Addendum No. 1

East Pearl Street Parking Lot Improvements

For City of Jerseyville
Jersey County, Illinois

H&A File No. 140-337
March 11, 2021

SITE PLAN
EAST PEARL STREET PARKING LOT
IMPROVEMENTS

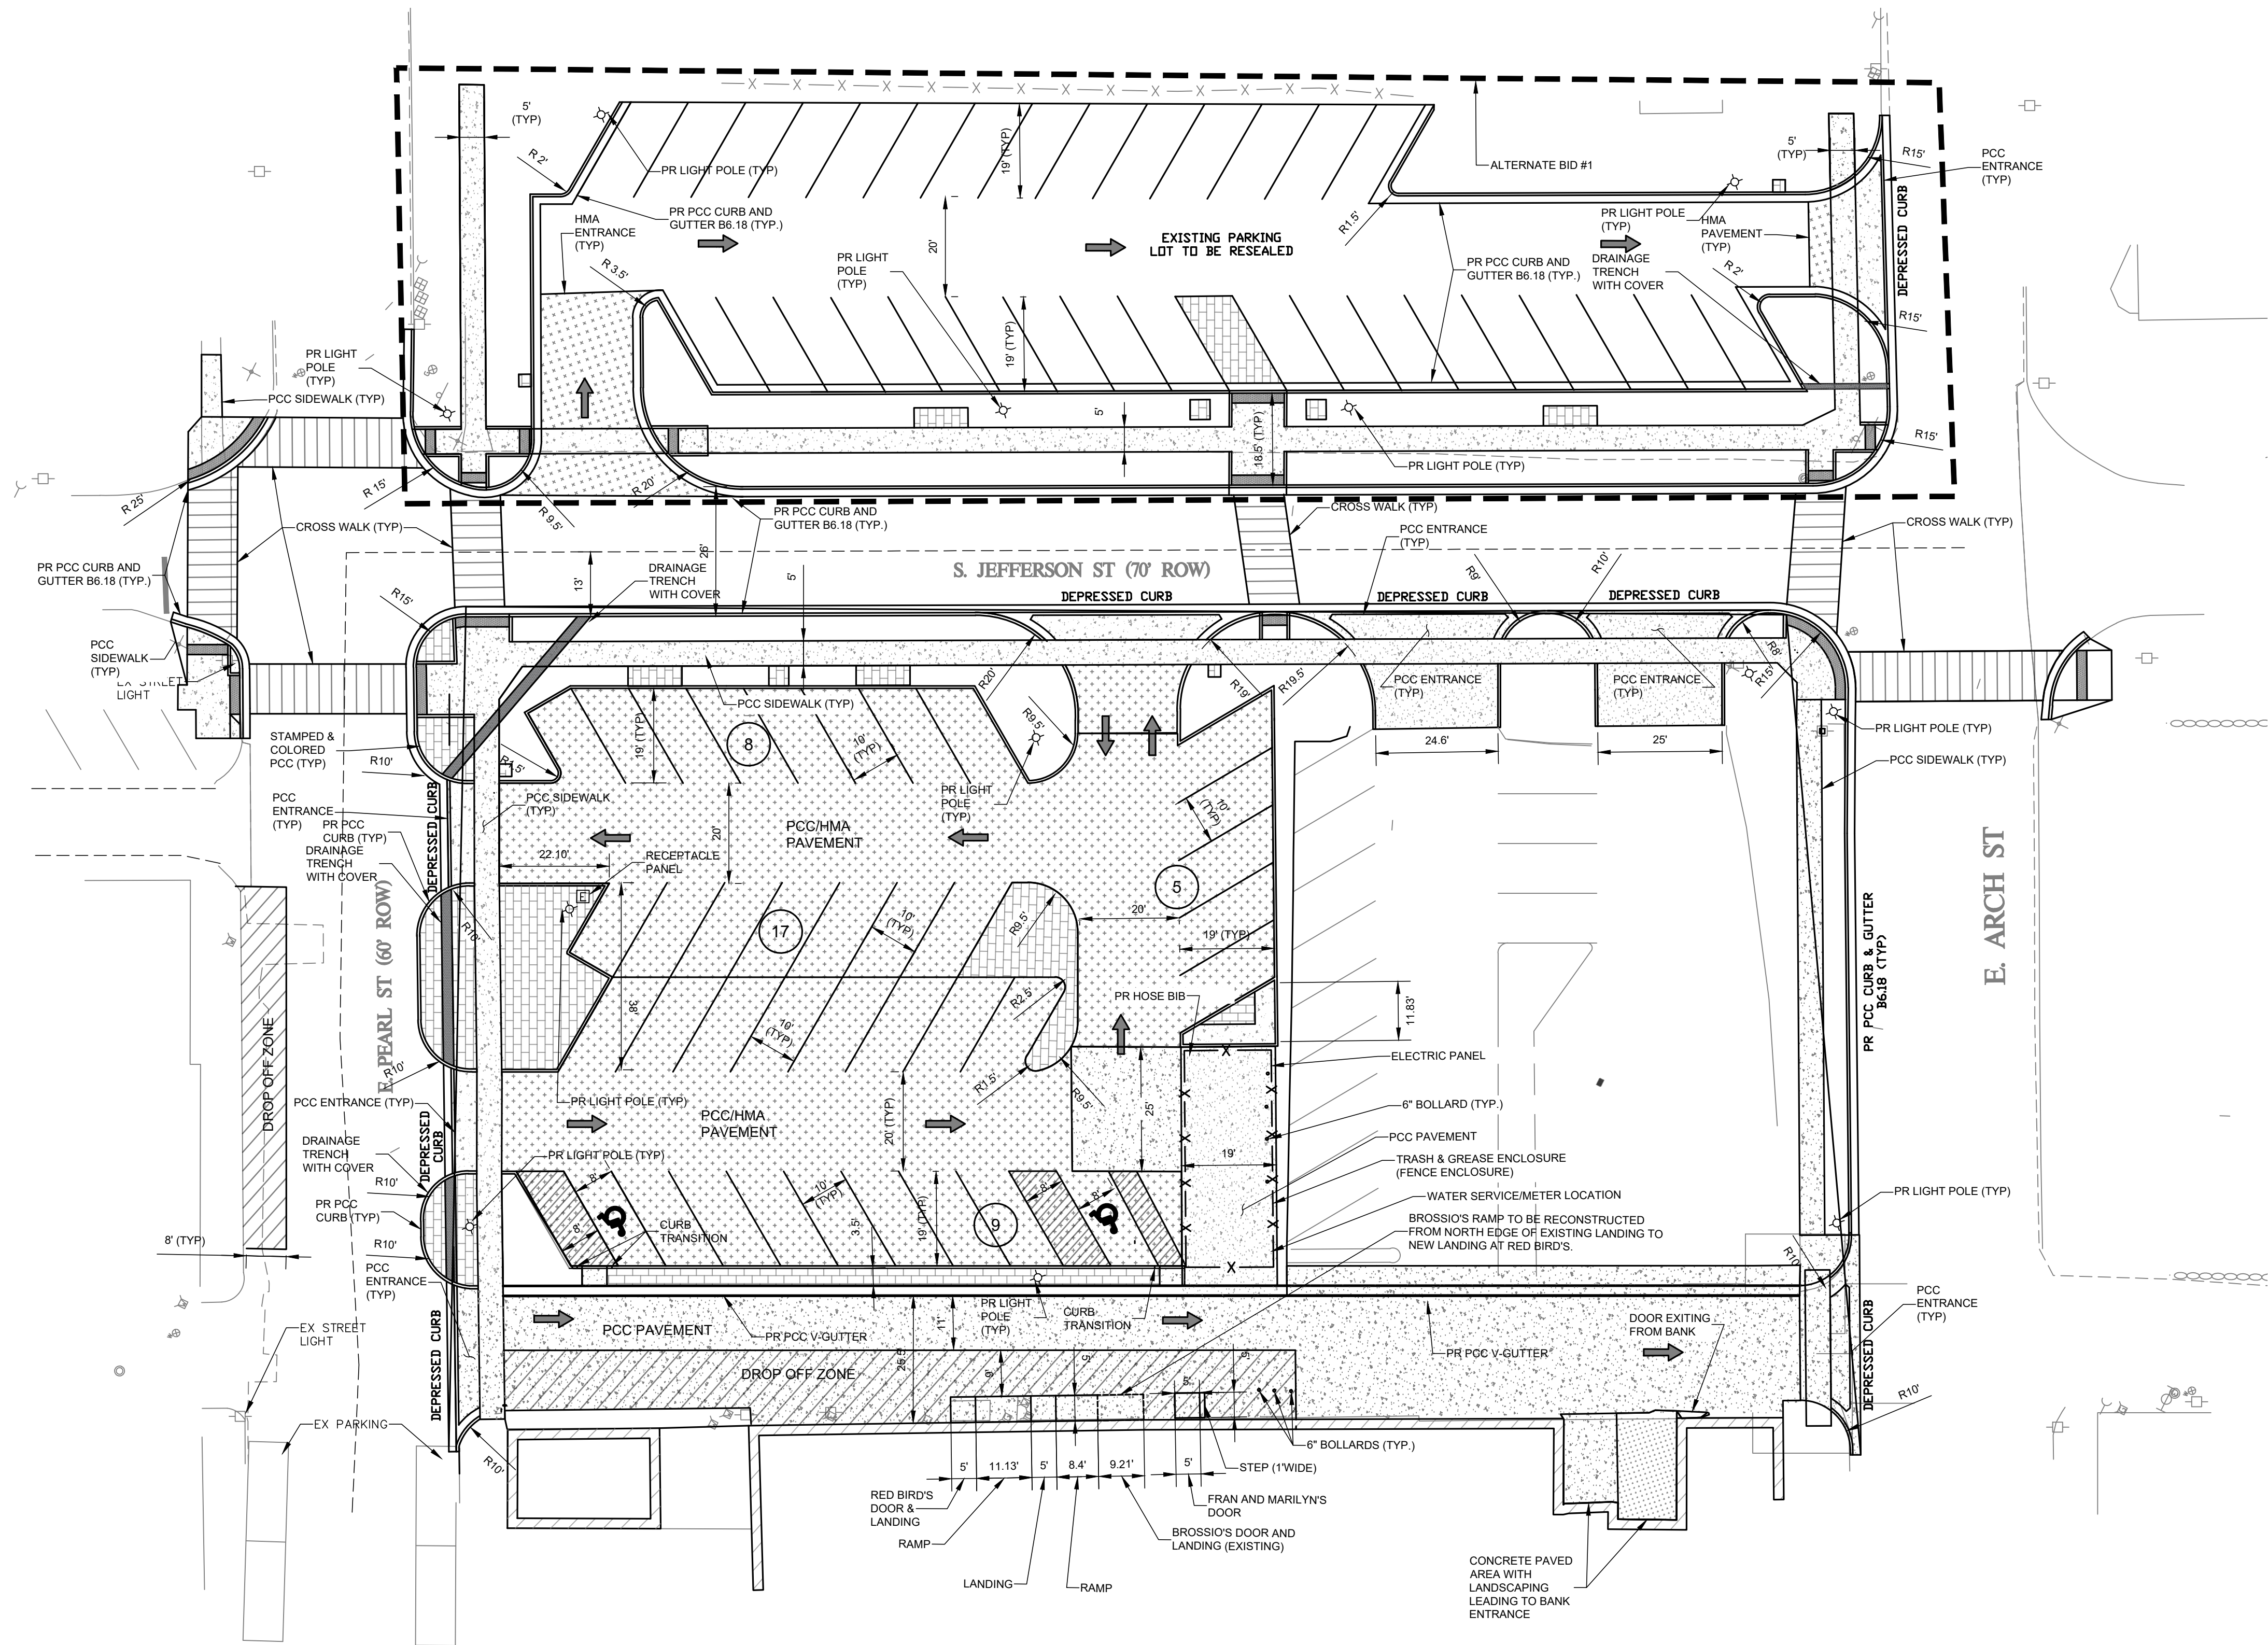
Sheet 5: Added curb ramps on the north side of Pearl Street and made revisions to entrances on Pearl Street.

SHEET NO. 6

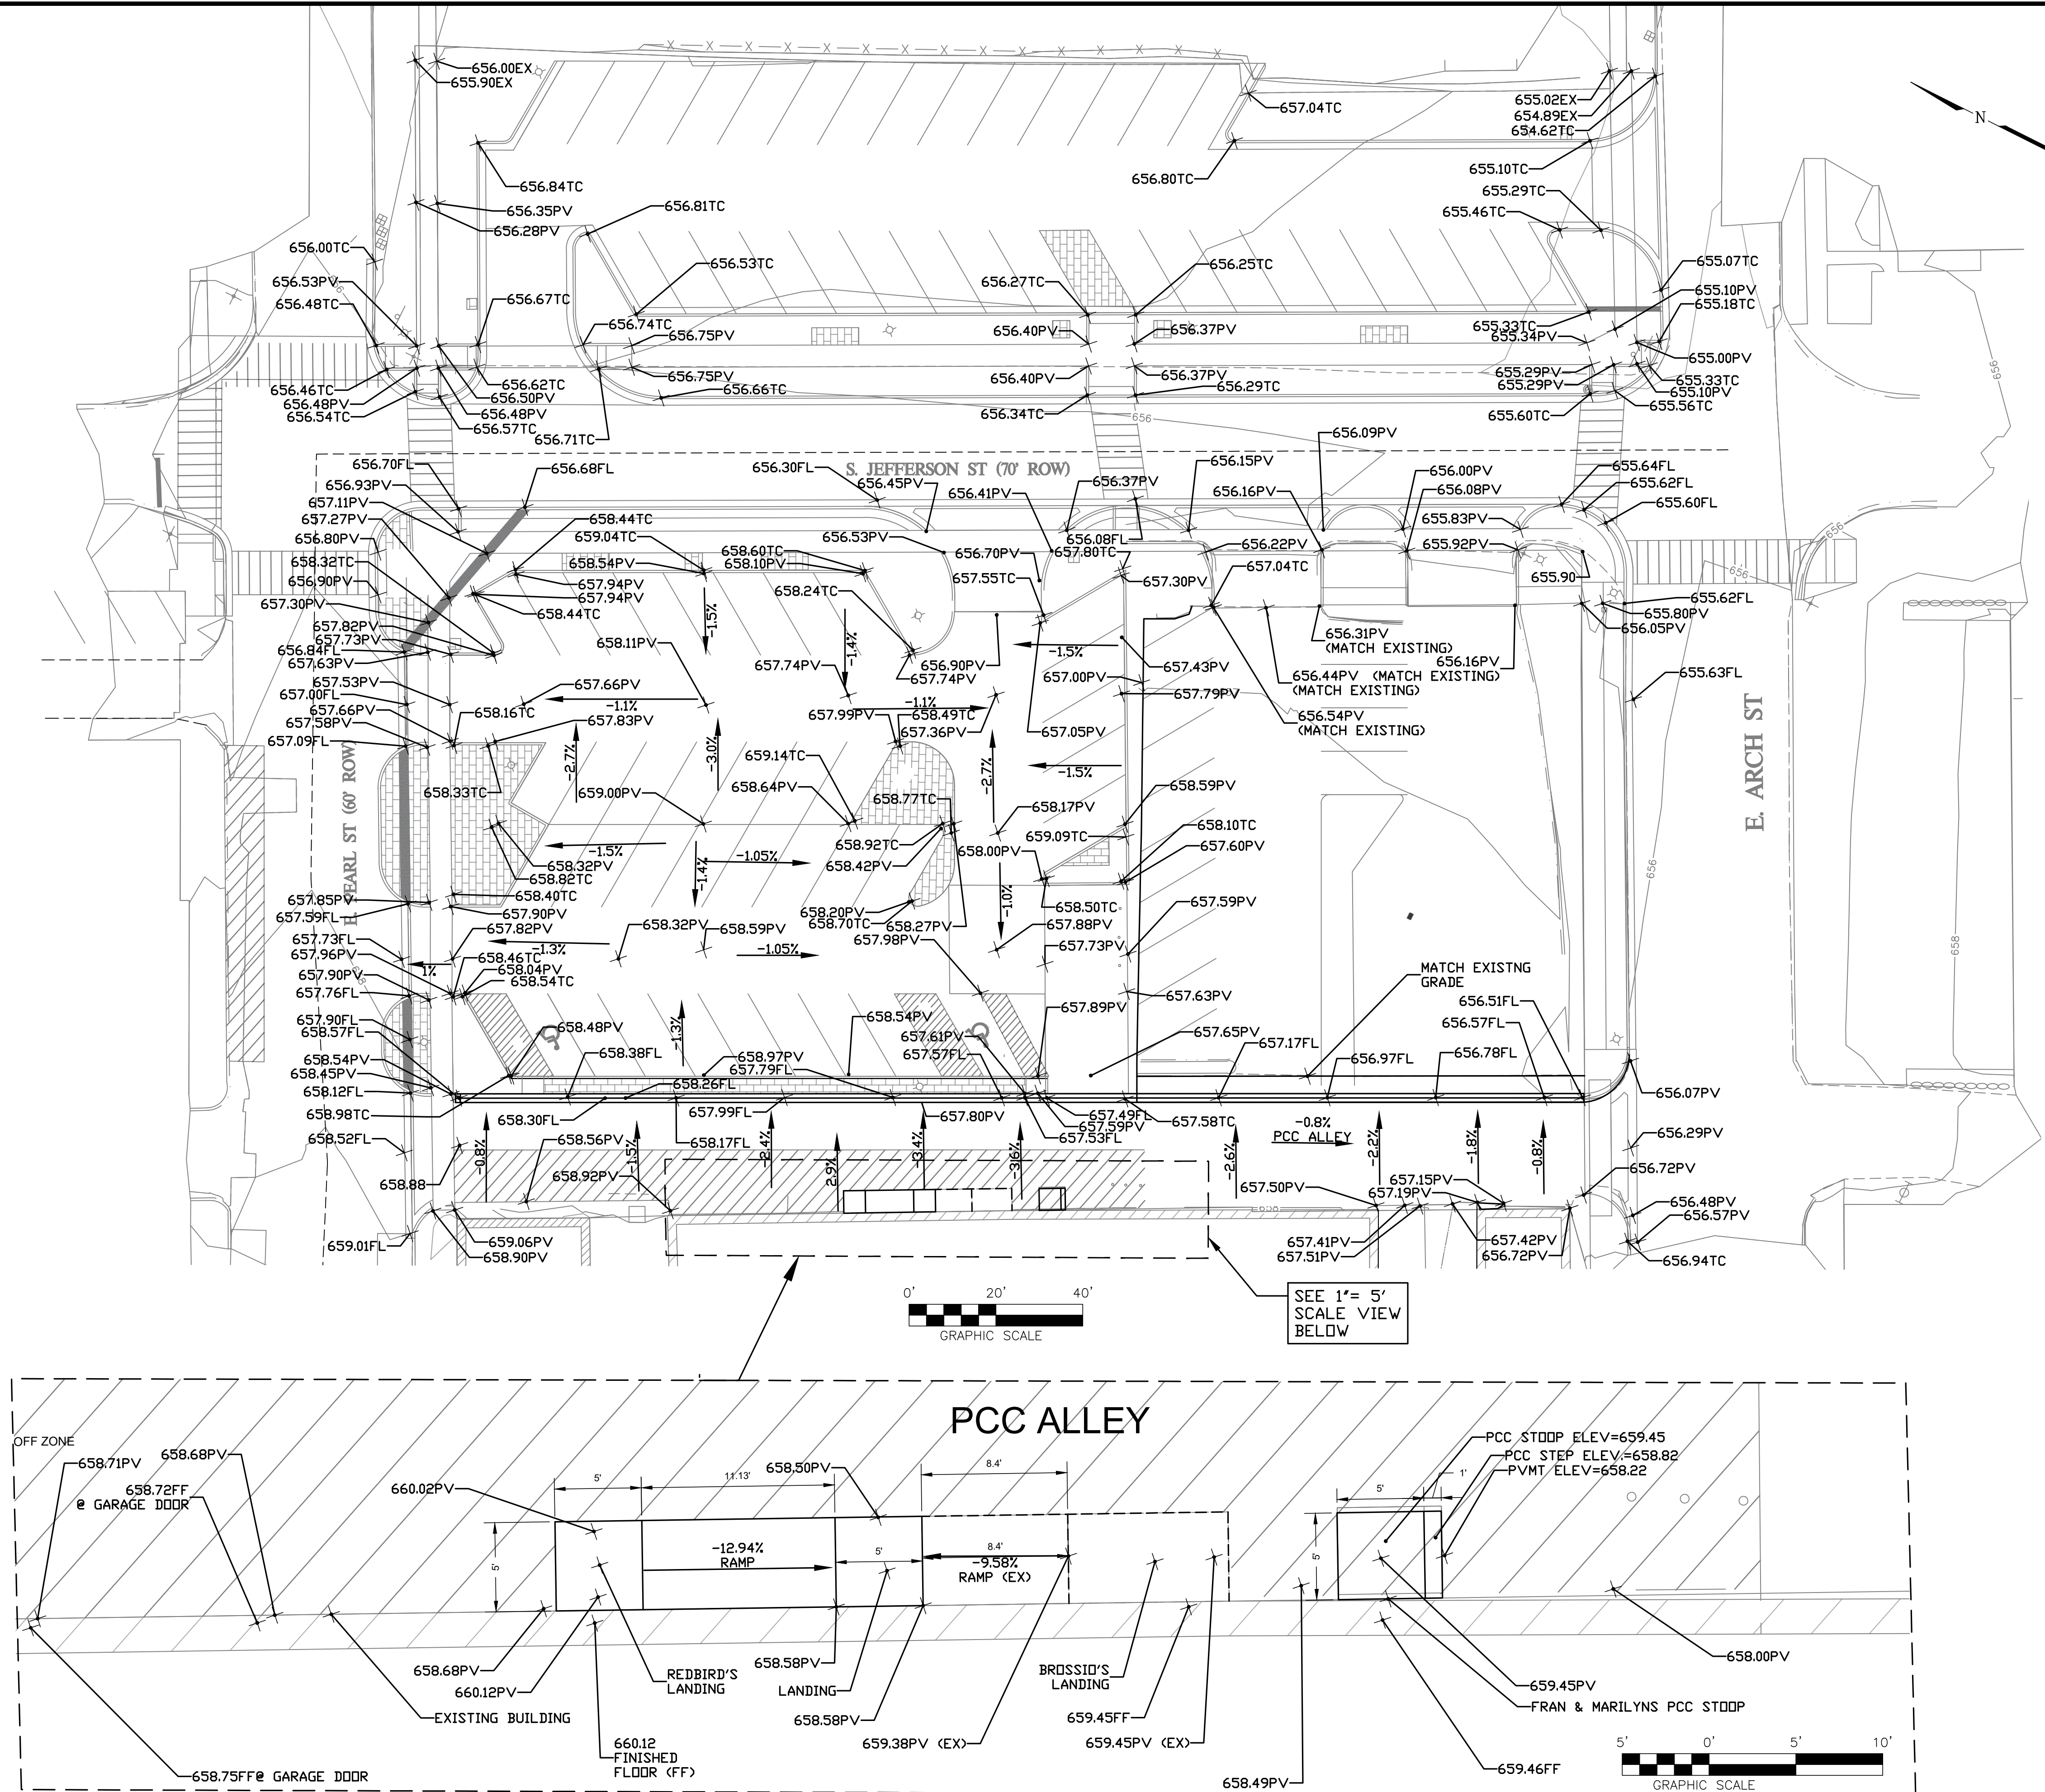
Sheet 6: Added curb ramps on the north side of Pearl Street and made revisions to entrances on Pearl Street
